**COMMONWEALTH OF KENTUCKY**  
**BEFORE THE PUBLIC SERVICE COMMISSION**

<b>APPLICATION OF BELLSOUTH</b>	)	
<b>TELECOMMUNICATIONS, LLC FOR</b>	)	<b>CASE NO. 2015-00227</b>
<b>DECLARATORY ORDER REGARDING</b>	)	
<b>INTERCONNECTION WITH CENTRAL</b>	)	
<b>KENTUCKY NETWORK FOR 911/E911</b>	)	
<b>SERVICES TO PUBLIC SAFETY</b>	)	
<b>ANSWERING POINTS</b>	)

**LEXINGTON-FAYETTE URBAN COUNTY GOVERNMENT'S  
REPOSSES TO AT&T KENTUCKY'S FIRST SET OF  
DISCOVERY REQUESTS  
JUNE 30, 2016**

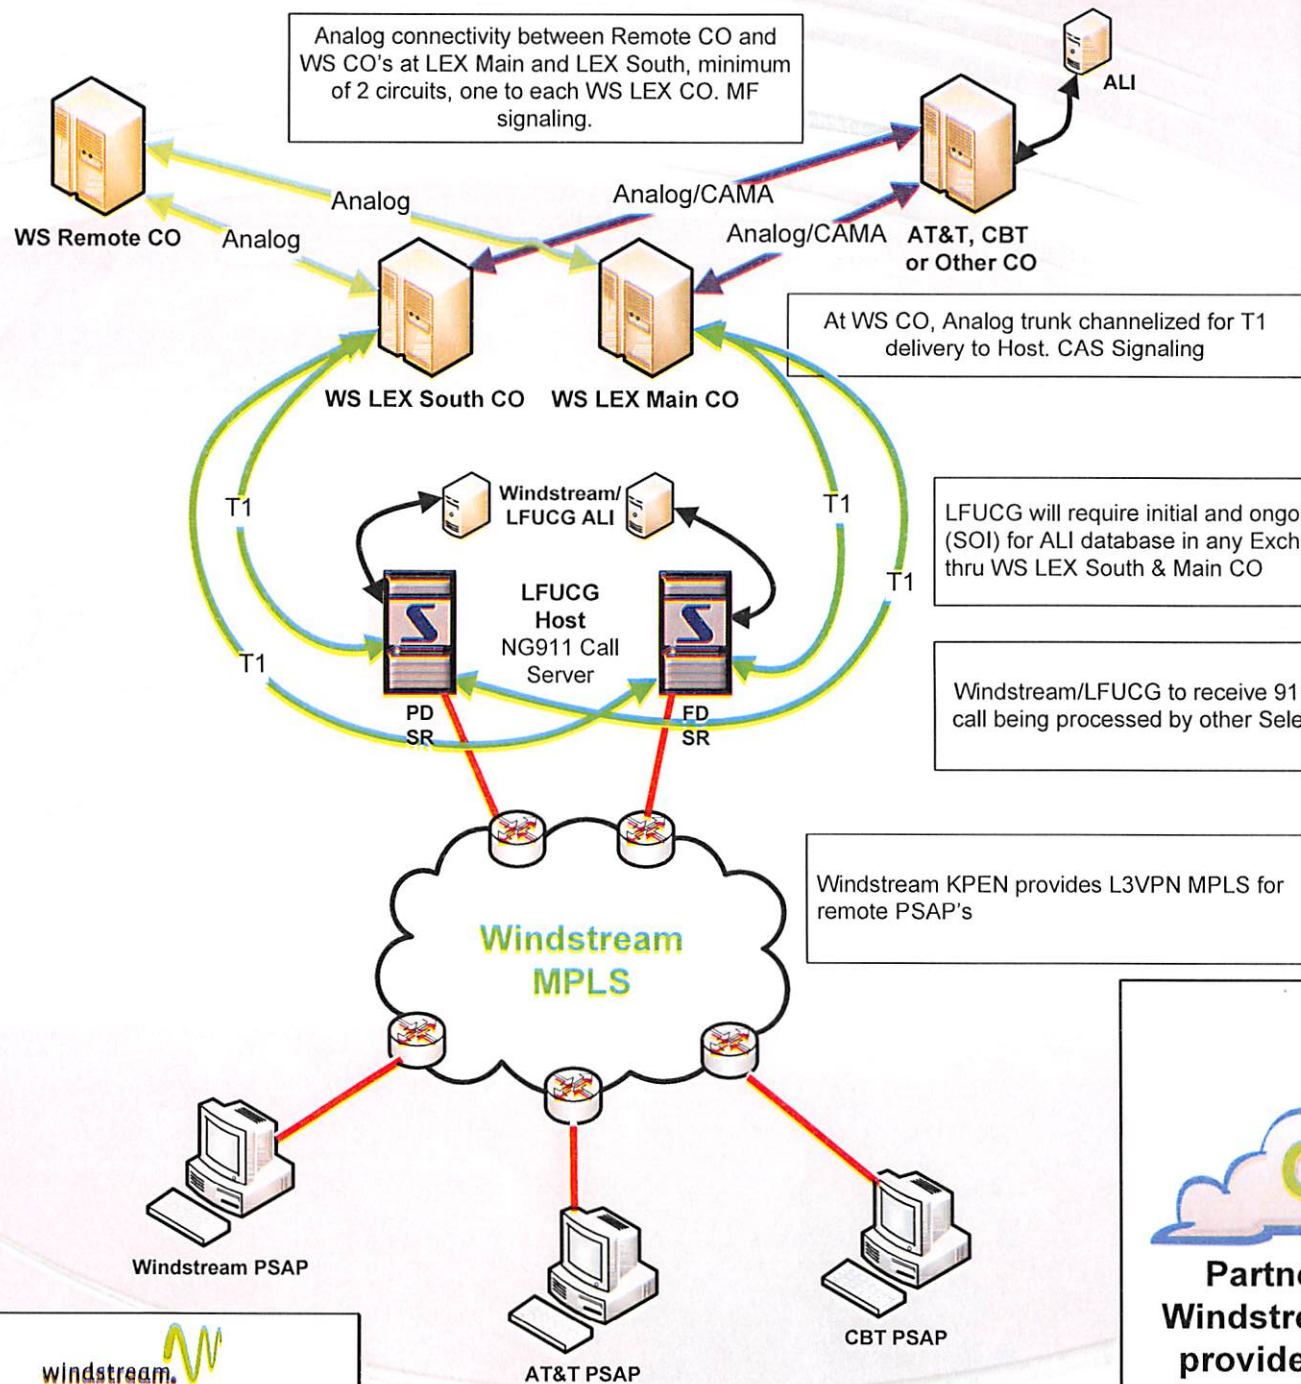
20  
21 4. In Exhibit LFUCG 1, the first paragraph/note of the narrative states: "New  
22 AT&T CAMA Trk's for landline will be transferred to a Media Gateway and pointed to the  
23 CKy911Net CPE."

a. AT&T Kentucky assumes “Trk’s” to mean Trunks. If “Trk’s” means something different, please identify what is meant by “Trk’s”.

b. In situations where AT&T Kentucky CAMA trunks currently exist at a PSAP that is transitioning to CKN, is it CKN’s or the PSAPs’ intent to install new AT&T Kentucky CAMA trunks or use the existing AT&T Kentucky CAMA trunks to connect to the proposed Media Gateway? If CKN or the PSAP are proposing new trunks where CAMA trunks already exist, please explain why there would be a need/requirement for AT&T Kentucky to install new AT&T CAMA trunks and what would happen to the existing CAMA trunks.

c. In situations where the PSAP handles 911 calls from AT&T end-users in the PSAP’s jurisdiction and AT&T CAMA trunks do not currently exist at a

1 PSAP that is transitioning to CKN, it is AT&T's understanding that the  
2 transitioning PSAP would order 911 service from AT&T Kentucky pursuant  
3 to AT&T Kentucky's tariff so that AT&T Kentucky end-user 911 calls can  
4 route to the PSAP's Media Gateway via newly established CAMA trunks.  
5 Is AT&T Kentucky's understanding consistent with the understanding of  
6 LFUCG and the PSAPs? If not, please explain why not.

9  
10 d. Is the proposed Media Gateway provided and provisioned by either CKN  
11 or the PSAP? If not, who would provide and provision the proposed Media  
12 Gateway?

16  
17 e. It is AT&T Kentucky's understanding that CKN or the PSAP, not AT&T  
18 Kentucky, would take the AT&T CAMA trunks from AT&T Kentucky's  
19 demarcation point and terminate the trunks to the proposed Media  
20 Gateway. Is AT&T Kentucky's understanding consistent with LFUCG's? If  
21 not, please explain why not.

1           5. In Exhibit LFUCG 1, the second paragraph/note of the narrative states: “A  
2 Controller In-Bound Call Policy will be established, for each trunk, pointing the traffic  
3 back to the PSAP’s Guardian ER Ring Group.”

4  
5           a. It is AT&T Kentucky’s position that the second paragraph/note should  
6 specifically state: “A Controller In-Bound Call Policy will be established **by**  
7 **CKN**, for each trunk, pointing the traffic back to the PSAP’s Guardian ER  
8 Ring Group,” as it is AT&T Kentucky’s position that the responsible party  
9 (in this instance CKN) must be clearly delineated. Is AT&T Kentucky’s  
10 position consistent with LFUCG’s? If not, please explain why not.

13  
14           6. In Exhibit LFUCG 1, the third paragraph/note of the narrative states: “Only  
15 AT&T Tandem Transfers (Star Codes) will be allowed, not CKy911Net Tandem  
16 Transfers, and remain the responsibility of AT&T for Tandem Transfers”

17  
18           a. It is AT&T Kentucky’s position that the parties should make clear that  
19 AT&T Kentucky will make no changes to the features and functionality  
20 (speed dials, etc.) of the existing AT&T Kentucky tandem trunks, and that  
21 any request for changes must come from the local PSAP (e.g., Laurel  
22 County). Is AT&T Kentucky’s position consistent with LFUCG’s? If not,  
23 please explain why not.

6  
7           b. It is also AT&T Kentucky's position that it will bill the local PSAP for all  
8           services it performs for the PSAP (e.g., ANI and Selective Routing). Is  
9           AT&T Kentucky's understanding/position consistent with LFUCG's? If not,  
10          please explain why not.

13  
14          7. In Exhibit LFUCG 1, the fifth paragraph/note of the narrative states: "The cost  
15          of the individual 911 CAMA trunks would be the responsibility of each PSAP needing  
16          such and would agree to said additional cost."

17  
18          a. It is AT&T Kentucky's understanding that for AT&T Kentucky ILEC landline  
19          customers, AT&T Kentucky would, pursuant to its tariff, bill the PSAP for  
20          ANI and Selective Routing, per thousand AT&T Kentucky ILEC access  
21          lines. Therefore, AT&T Kentucky proposes that the fifth paragraph/note  
22          read: "For AT&T ILEC landline customers, AT&T Kentucky will bill the  
23          PSAP for ANI and Selective Routing, per thousand AT&T ILEC access

1 lines.” Is AT&T Kentucky’s understanding consistent with LFUCG’s? If not,  
2 please explain why not.

8  
9 8. AT&T Kentucky proposes that for purposes of clarity, there be inserted a  
10 dotted line in Exhibit LFUCG 1 to clearly delineate the responsibilities of AT&T Kentucky  
11 vs. CKN or the PSAP, and that the dotted line start at the top to the right of the AT&T  
12 Kentucky SR and go down to the right of the AT&T Kentucky demarc for 9-1-1 CAMA  
13 trunks such that the AT&T Kentucky Landline Customer, AT&T Kentucky SR and AT&T  
14 Kentucky DeMarc 911 CAMA’s are positioned to the left of this dotted line to reflect  
15 AT&T Kentucky’s area of responsibility. Does LFUCG agree with AT&T Kentucky’s  
16 recommendation? If not, please explain why not.

1           9. In Exhibit LFUCG 1, the diagram depicts "Carrier T-1's" between an ISPR and  
2 a building.

3  
4           a. It is AT&T Kentucky's position that the parties should make clear that is  
5 the "ISPR" a CKN selective router? If not, what is the ISPR?

8  
9           b. What are the "Carrier T-1's" and are any of those AT&T Kentucky T-1's or  
10 do they contain AT&T Kentucky trunks from an AT&T Kentucky switch  
11 (AT&T Kentucky end office or 911 Tandem/Selective Router)?

17  
18           10. Regarding the issue of trouble shooting in relation to Mr. Stack's 5/19/16  
19 testimony and Exhibit LFUCG 1, it is AT&T Kentucky's understanding that AT&T  
20 Kentucky will test to its existing AT&T 9-1-1 CAMA trunk demarc, and that CKN or the  
21 PSAP will then do any necessary testing beyond that point. Is AT&T Kentucky's  
22 understanding consistent with LFUCG's? If not, please explain why not.

RESPONSE: “Trks” means “trunks”.

RESPONSE: If there are existing AT&T Cama Trunks at the PSAP in question, then those AT&T 911 Cama Trunks can be used. However, if the PSAP in question does not currently have AT&T Cama Trunks, then that PSAP will request those services from AT&T. Neither CKN, nor the PSAP making the request, is proposing new Cama Trunks where they already exist.

7  
8 RESPONSE: Yes

13  
14 RESPONSE: Yes. The Solacom Media Gateway is provided and  
15 provisioned by CKN. The media gateway is the property of the PSAP.

22  
23 RESPONSE: Yes.

11  
12           RESPONSE: Yes. The in-bound call policy is established by CKN.

1           **RESPONSE:** Yes. Existing AT&T Tandem Transfers (a/k/a Star Codes)  
2           will remain in effect. It is CKN's position not to ask for changes to AT&T  
3           functions and features. However, this position does not preclude the  
4           PSAP from communicating requested changes with AT&T as part of their  
5           business relationship.

11  
12          **RESPONSE:** Yes it is.

3  
4 RESPONSE: CKN takes no position on AT&T’s tariffs and its business  
5 relationship and agreement with a particular PSAP, therefore CKN does  
6 not agree with the proposition that the 5<sup>th</sup> paragraph in Exhibit 1 needs to  
7 change.

17  
18 RESPONSE: CKN does not agree with adding a dotted line to the  
19 diagram. If there is a connection issue involving the AT&T Cama Trunk  
20 passing information, then AT&T, the PSAP, and CKN need to work  
21 together toward a resolution. A dotted line suggests to CKN that AT&T’s  
22 responsibility ends with the delivery of the Cama Trunk.

6  
7           RESPONSE: Yes.

12  
13           RESPONSE: The T-1's noted are T-1 Circuits from various ILEC, CLEC,  
14 VSP, and wireless telephone service providers operating within the  
15 partner PSAP's jurisdiction/service area. This excludes AT&T Kentucky  
16 circuits.

1           **RESPONSE:** Upon connection to the CKN Media Gateway, AT&T will  
2 work and test jointly with AK Associates, the managed services provider  
3 for CKN, to ensure “Wink Test” and operational status of the trunks, before  
4 said trunks are placed into service. It is CKN’s understanding that testing  
5 will include both circuit tests and call testing jointly conducted by AT&T  
6 and CKN via AK Associates, and testing will not be considered complete  
7 until it can be proven that by all parties (i.e., AT&T, PSAP, and CKN) that  
8 AT&T customer 911 calls can be placed and received at the designated  
9 PSAP, complete with ANI and ALI delivery.

**Partnership between LFUCG, Windstream and AK Associates to provide NG911 Hosting Solution**

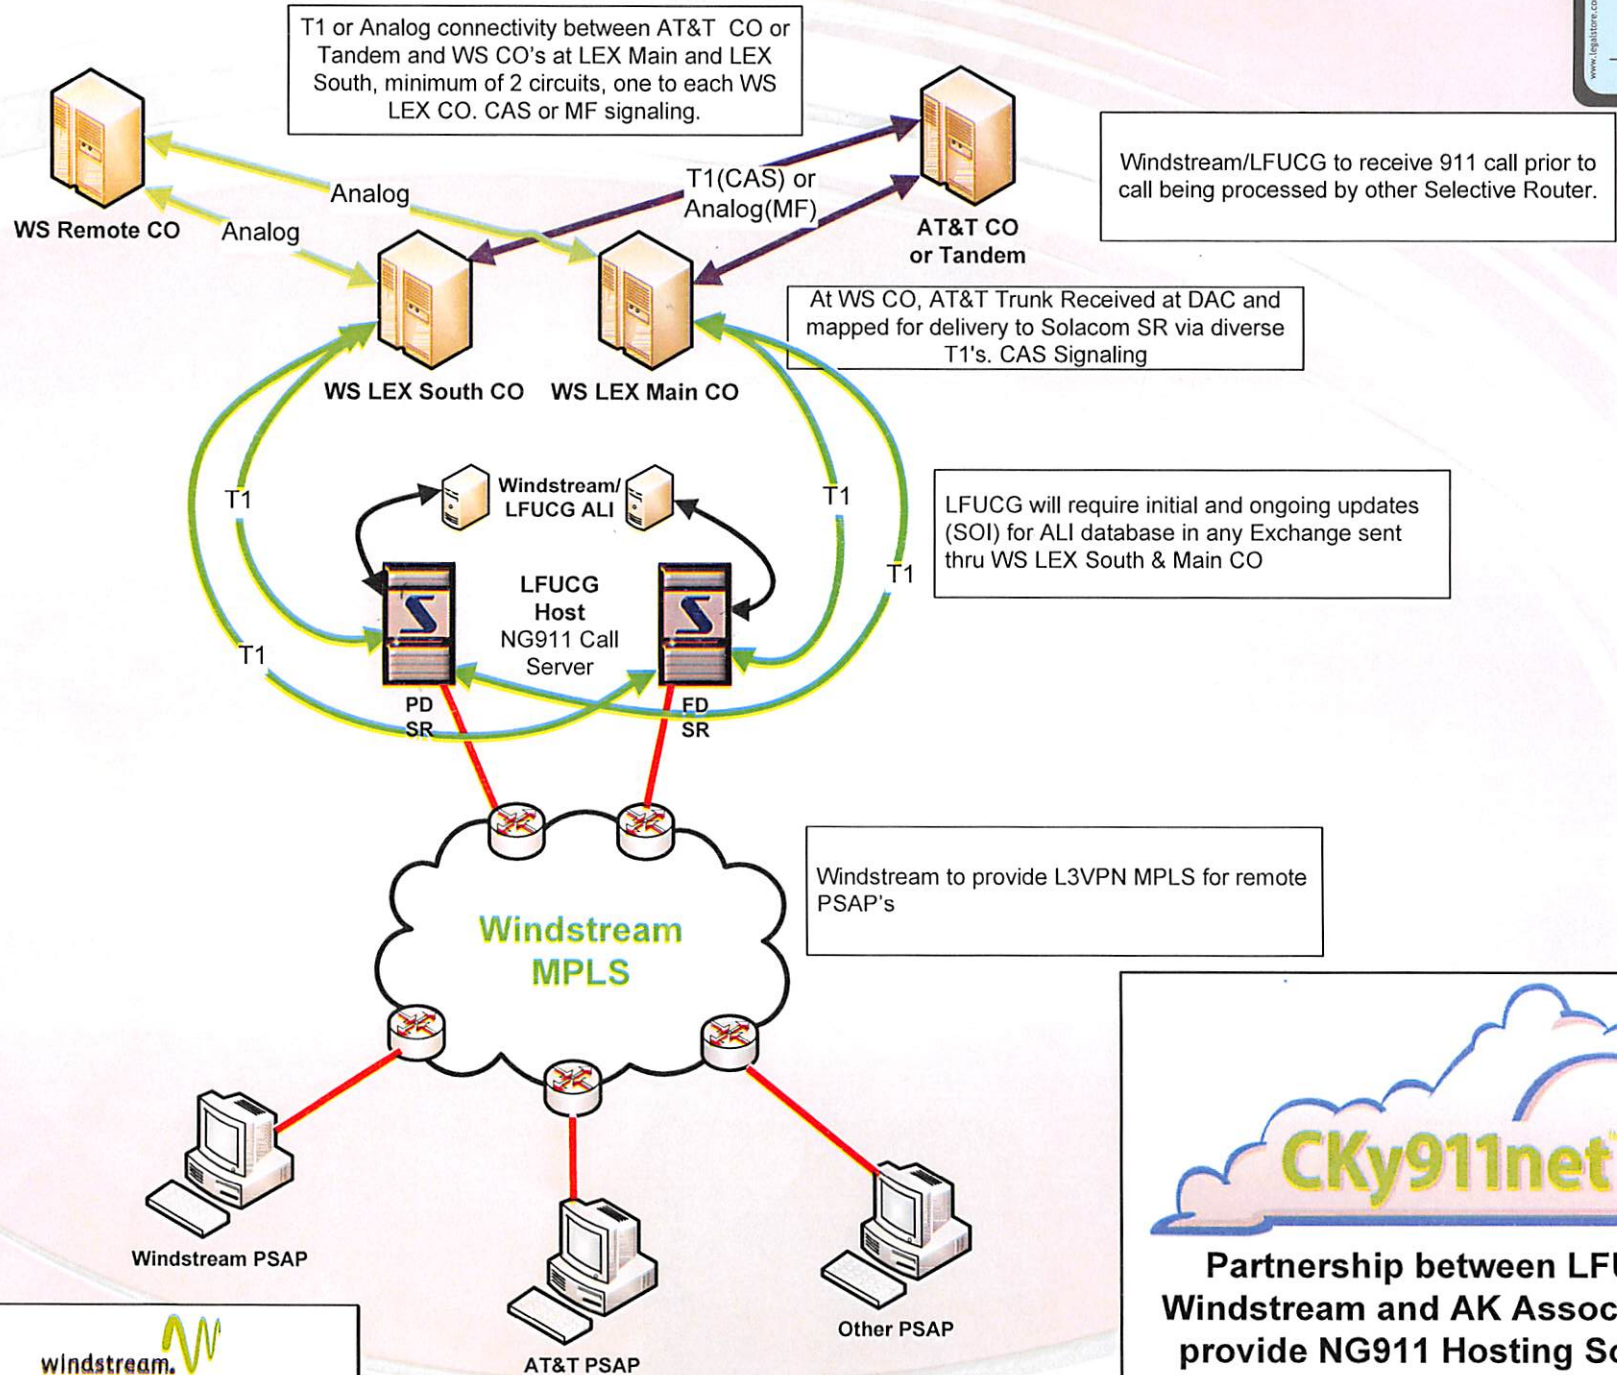
17  
18           2. CKN and Windstream made a network diagram available to the parties,  
19 including AT&T Kentucky, attending the informal conference held at the KPSC on  
20 February 12, 2014. The diagram was titled "CKy911net Partnership between LFUCG,  
21 Windstream and AK Associates to provide NG911 Hosting Solution." CKN provided an  
22 updated version of the diagram to AT&T Kentucky on April 9, 2014. Did CKN use this  
23 diagram to describe that it wanted AT&T Kentucky to connect trunks from AT&T

1 Kentucky's central office or tandem, not a Selective Router, and terminate them on  
2 CKN's Selective Router?

3  
4 RESPONSE: Windstream created the diagram dated February 14, 2014  
5 (Exhibit LFUCG 1) and made it available during an informal conference in  
6 February 2014, Windstream also created the updated version of the  
7 diagram dated April 7, 2014 (Exhibit LFUCG 2). CKN is uncertain if these  
8 diagrams were used to describe that the CKN wanted AT&T Kentucky to  
9 connect trunks from AT&T Kentucky's central office or tandem, not a  
10 Selective Router, and terminate them on CKN's Selective Router
